Ecology Response to F/22/93194 - Ageas Bowl Drainage 14/3/23

This response refers to Landscape Plan Area 5 (West) Sheet 5 of 6 rev 06 as shown below.

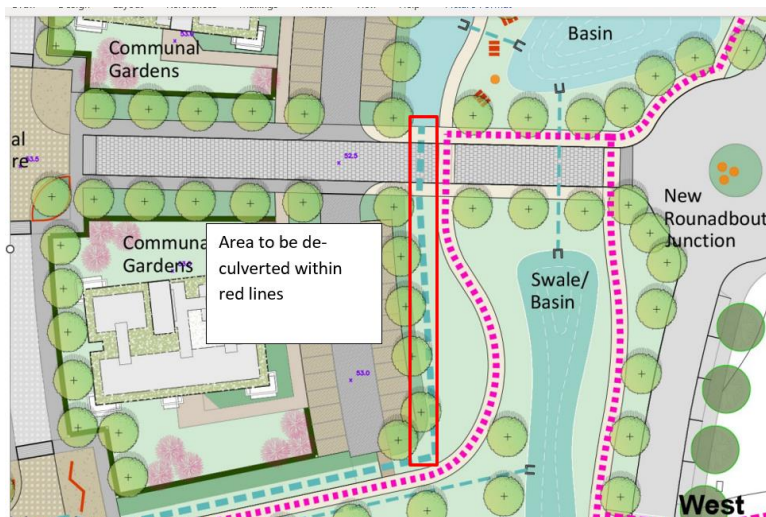
The diverted watercourse (thick dashed line) should be de-culverted as much as possible.

The area labelled Attenuation Pond should not be an attenuation pond. It is the watercourse, because the culverted Telegraph Brook flows into it when it exits the culvert. It should be profiled as a watercourse, and should be managed as a watercourse, with a low flow, two stage channel and not a trapezoidal channel.

The watercourse could be de-culverted south of where it is shown now, back to the right-angle bend. Eliminating the right-angle bend would also reduce the chances of blockages.

Most of area 5 is proposed to be drained by permeable paving, the swale/basin and the basin before discharge into the watercourse. This would provide 3 forms of filtration, of which 2 are naturalised.

The lakes within the golf course must provide another form of naturalised filtration for this water, the final level of treatment before it is discharged off site.

It is not clear which areas in this housing section (Area 5) are proposed to be drained by which features and where this runoff will enter the system. The thin dashed line starts just to the west of Orientation Square and flows into the Swale/Basin but it is not clear how and which drainage enters this path. The catchments need to be shown on this plan or on a simpler plan, because the compressed Appendix drainage documents are still too large, and I still cannot open them.

Surface water from all of the roads should drain through the permeable paving, the Swale/Basin and the Basin before draining into the main watercourse.

In this new plan, the old watercourse, labelled existing ditch, will not receive the main flow from Telegraph Brook. We need to know which areas are proposed to drain into to this ditch. The simple index approach needs to apply to any runoff before entering the ditch. This ditch cannot be managed as a swale, as it is shaded by the trees, which should be retained. Some water must enter this ditch so that it does not get starved of water and dry out. There was some discussion about the surface water drainage from the houses in area F and the apartment blocks draining into this ditch but it is not clear how this would work. What level of filtration would this watercourse with trees provide?
